**TOWN OF BAY HARBOR ISLANDS
PLANNING AND ZONING BOARD**

May 3, 2016

Subject: Site Development Plan Application
Request for Modifications to 2/3/15 PZB Approved Plans
1150 100th Street Townhouses – 4 DU Residential Complex
1150 100th Street
Bay Harbor Islands Acct. No. BP2015-467
MMPA Acct. No. 01-0702-1002

RE: CASA VERDE at Bay Harbor Islands, a Condominium
1140 – 1150 93 STREET, Bay Harbor Islands
NARRATIVE OF P&Z SUBMITTAL REVISIONS

DRAWING TITLE
WEST [SIDE]
COLOR ELEVATION
SCALE: - DATE: APRIL 14, 2016
SHEET NUMBER
A-2.02A
P&Z SUBMITTAL
PROPOSED REVISIONS

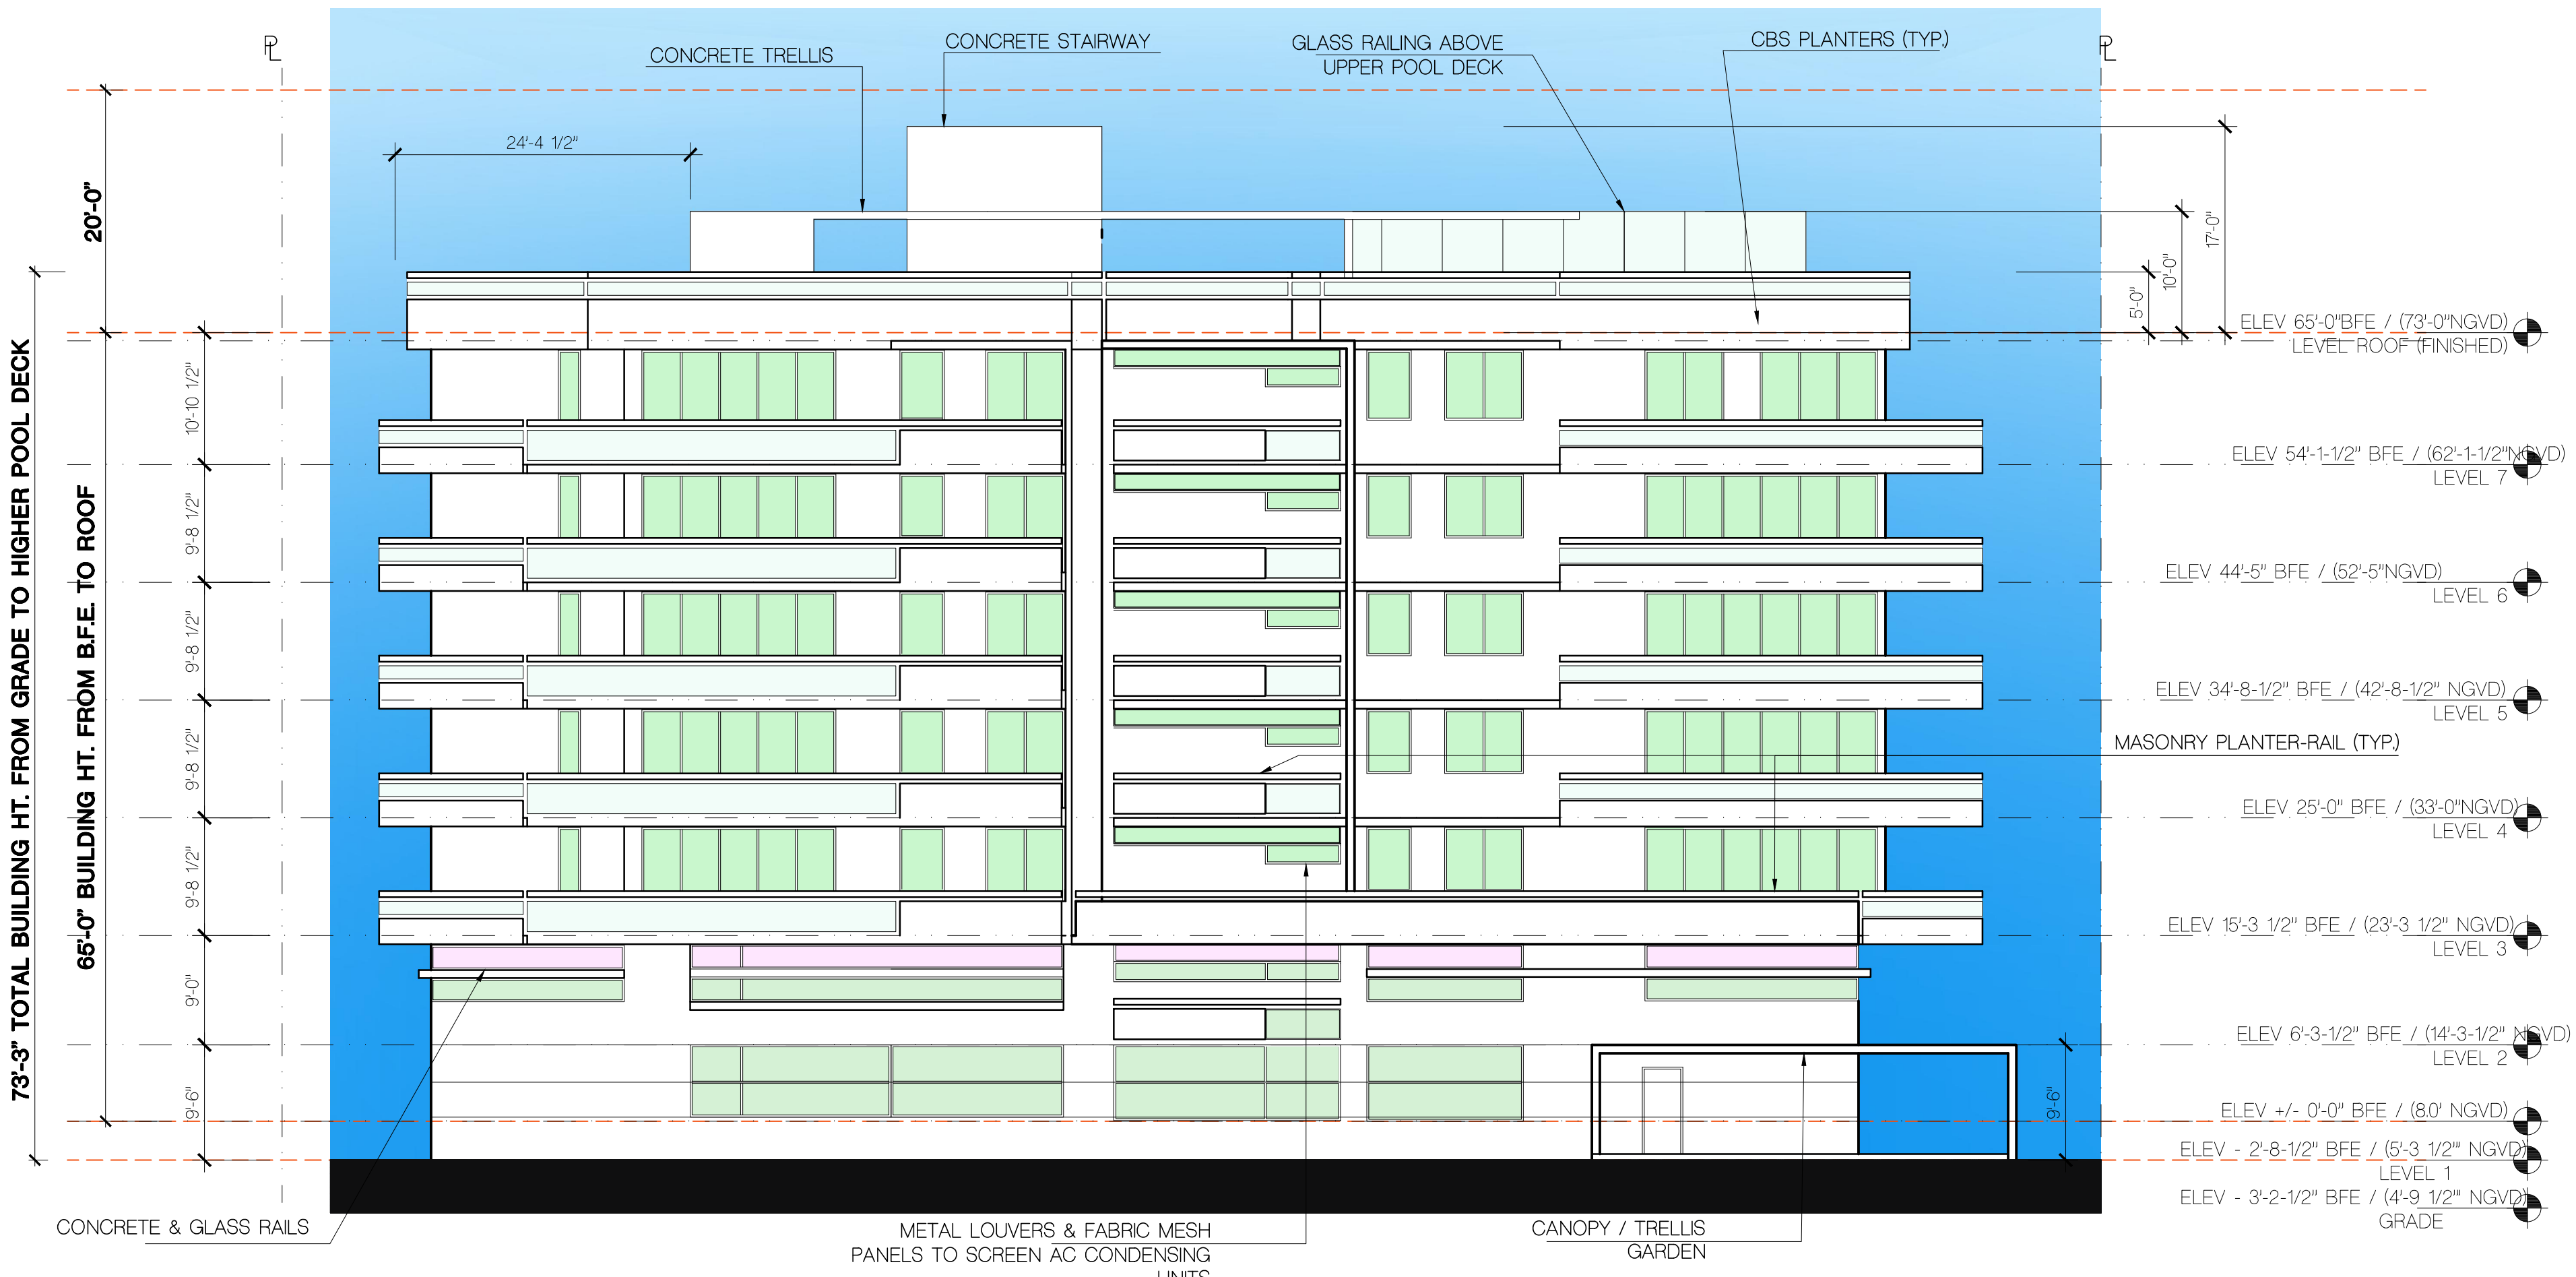
WEST ELEVATION:

- Changed configuration of garage openings.
- Changed configuration of stair & storage doors per MD Fire Dept. request.
- A Trellis is added at the SW corner per condition of the P&Z Board approval of January 20, 2015.
- Corrected graphics to show eyebrow corner column.
- Glass assemblies of North side of the façade are shifted slightly south.
- Glass assemblies at the center of the façade are shifted slightly south.
- South Stair height is reduced to 10' above roof deck.
- Top of elevators & North stair parapets are brought to 20' above Roof deck.
- Two doors are added at the roof deck for new Fire communication & pool equipment rooms.
- Graphics of glass insert around North stair are corrected by adding color.

**SOUTH [REAR]
COLOR ELEVATION**

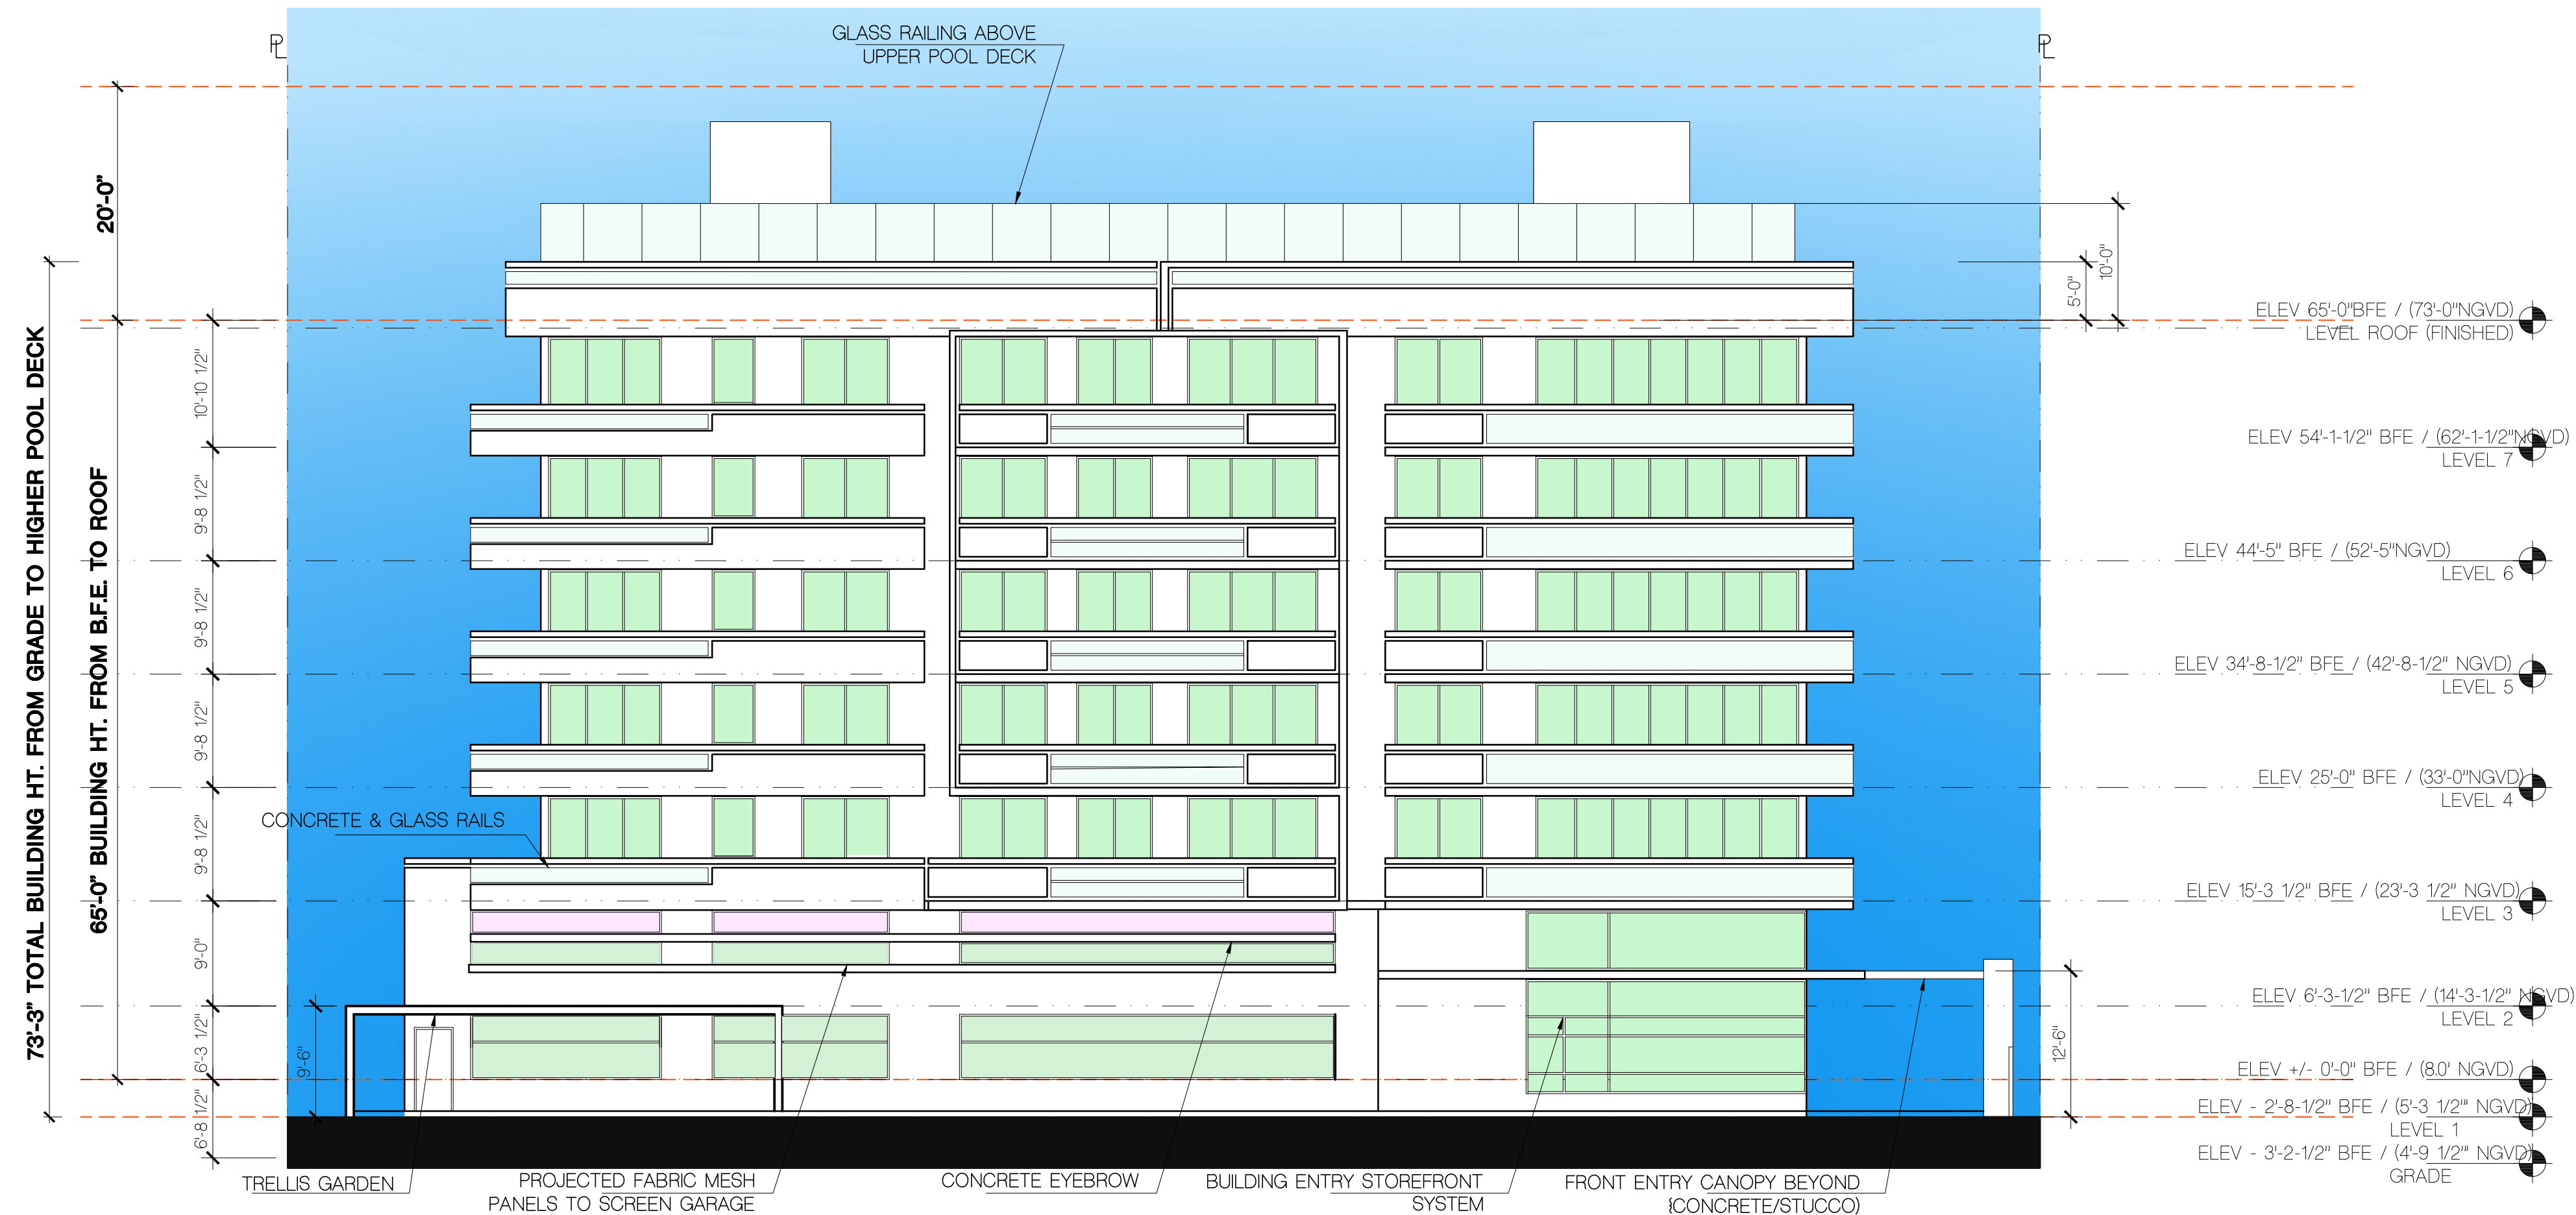
SOUTH ELEVATION

- Changed configuration of garage openings/fabric & metal panels.
- A Trellis is added at the SW corner per condition of the P&Z Board approval of January 20, 2015.
- Corrected graphics to show eyebrow & eyebrow corner column beyond.
- Added glass doors at the center bay of the façade.
- Graphics of roof volume projections are corrected.
- South Stair height is reduced to 10' above roof deck.
- Top of elevators & North stair parapets are brought to 20' above Roof deck.

EAST ELEVATION - P&Z BOARD REVISIONS - APRIL 14, 2016

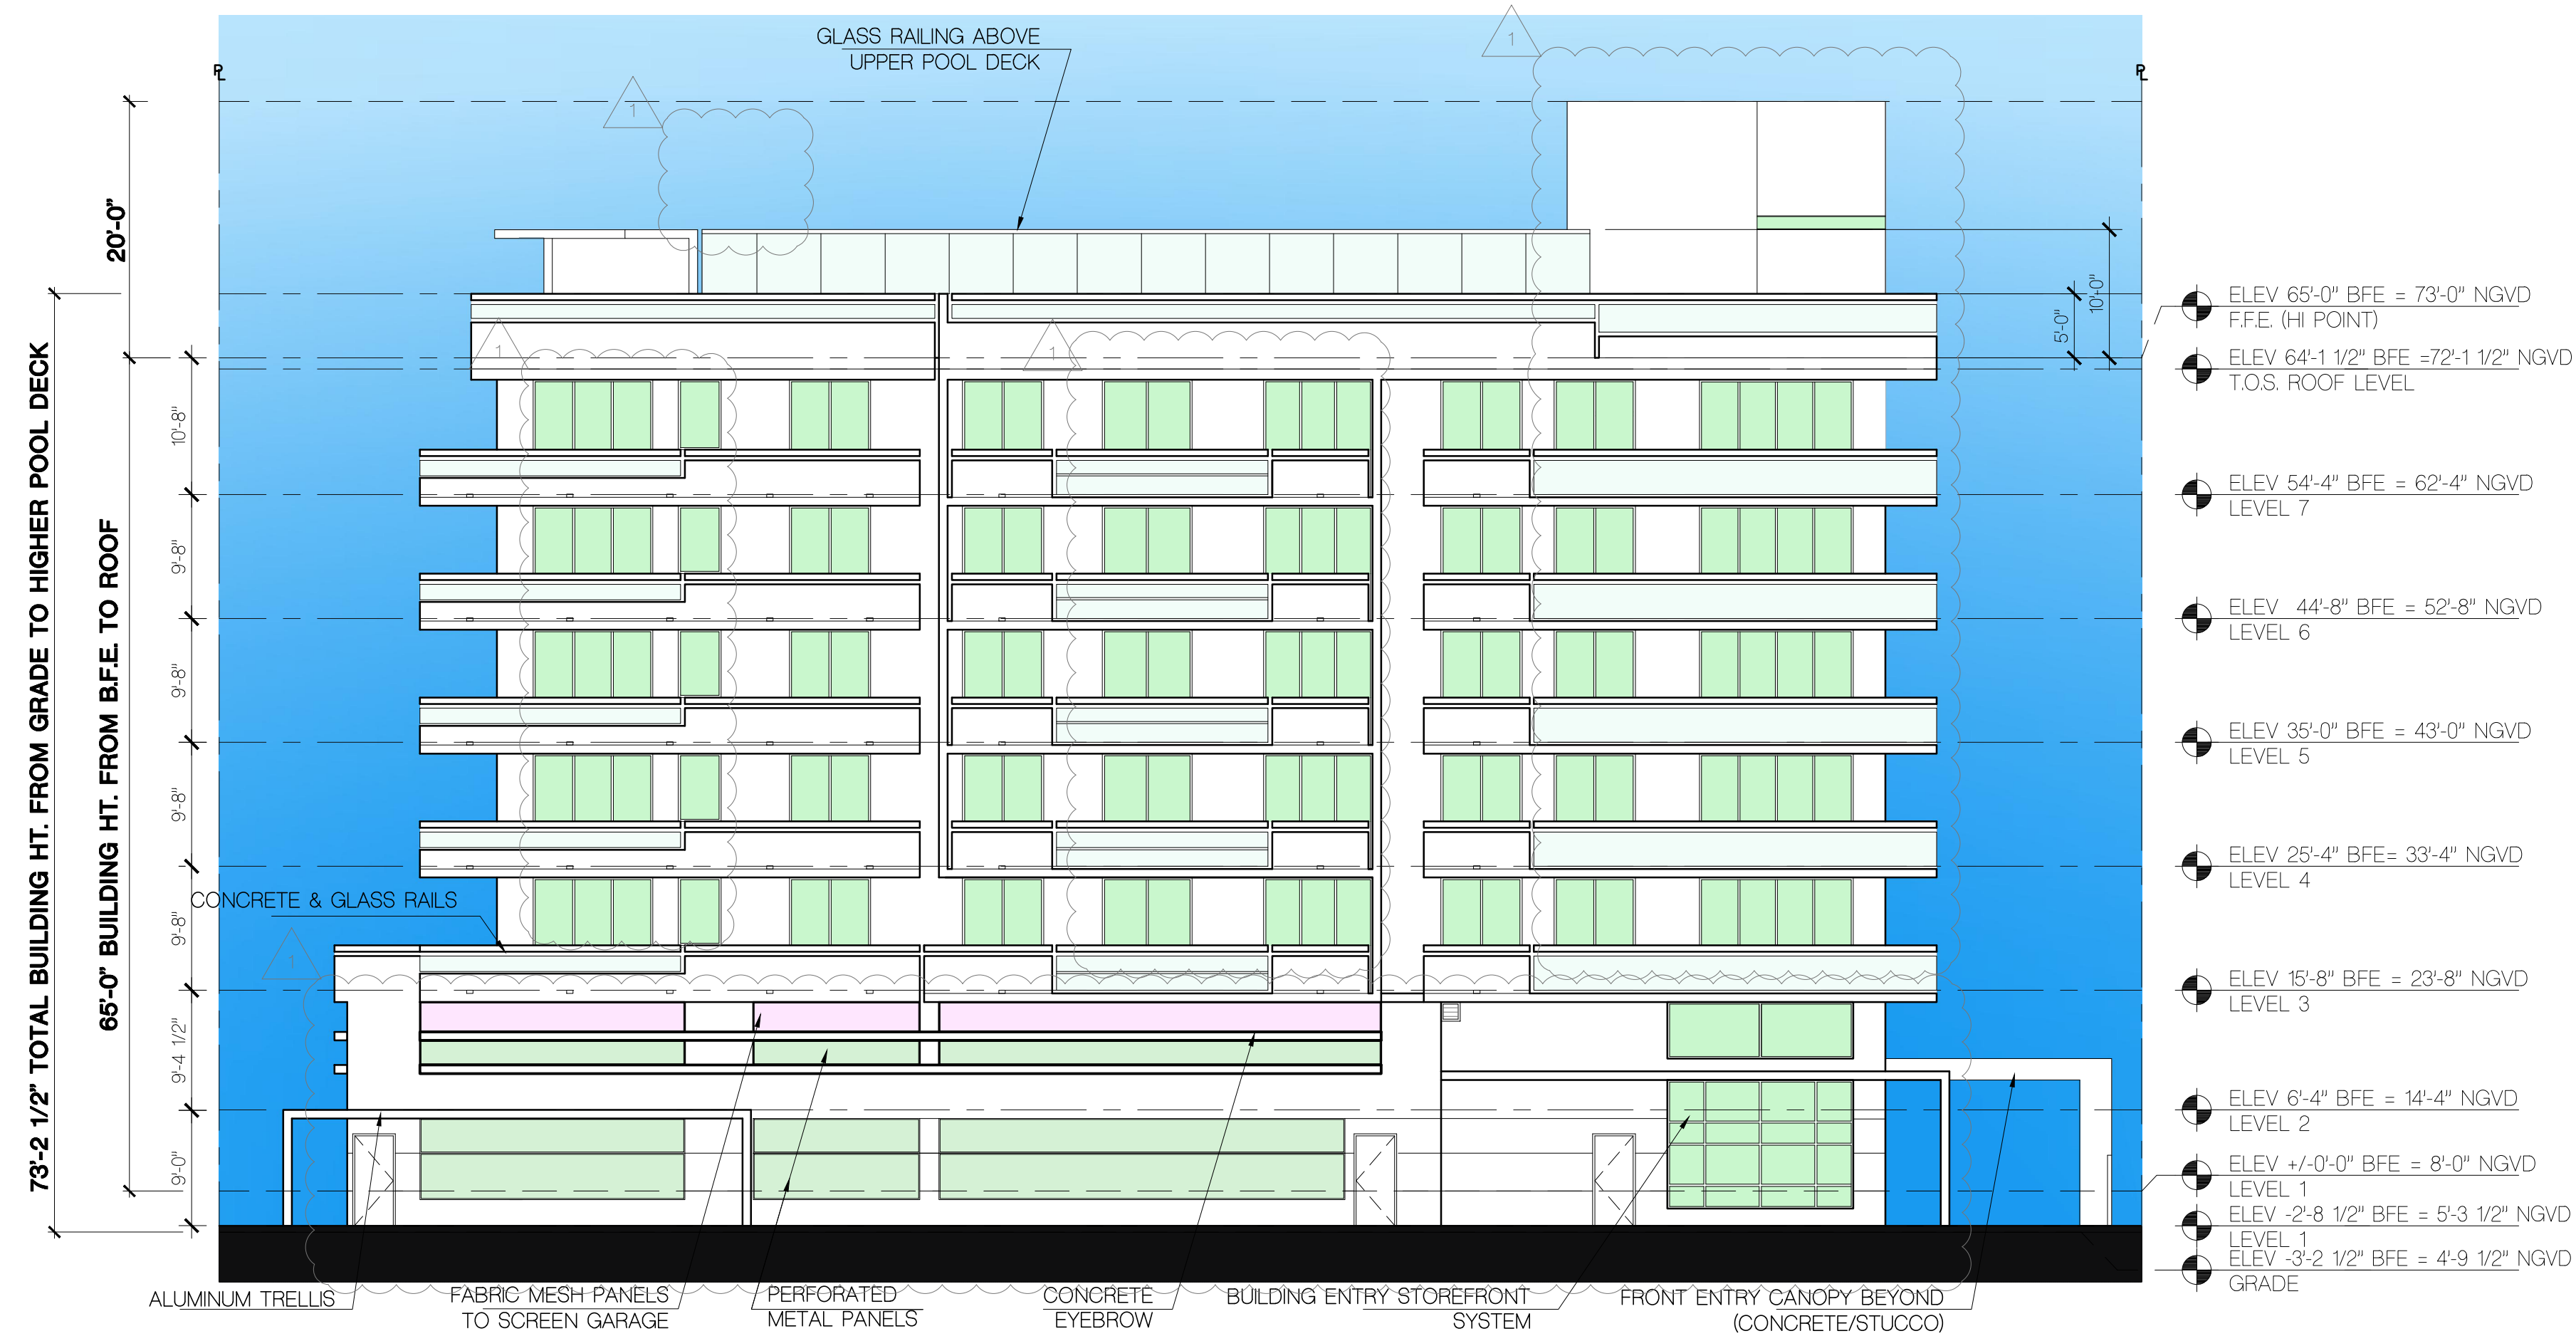
EAST ELEVATION

- Changed configuration of garage openings.
- Building entry storefront is changed, reflecting changes to level-2 Fire Pump access per Fire Department request.
- Corrected graphics to show eyebrow corner column.
- Units South glass doors are slightly shifted towards North.
- Separation between Unit's glass doors at the center bay, are increased.
- Unit's glass door assemblies of 7-panel, located at the North side, are changed for two assemblies: one of two-panel glass door & one of 5-panel glass door.
- Graphics of roof volume projections are corrected.
- South Stair height is reduced to 10' above roof deck.

- Top of elevators & North stair parapets are brought to 20' above Roof deck.
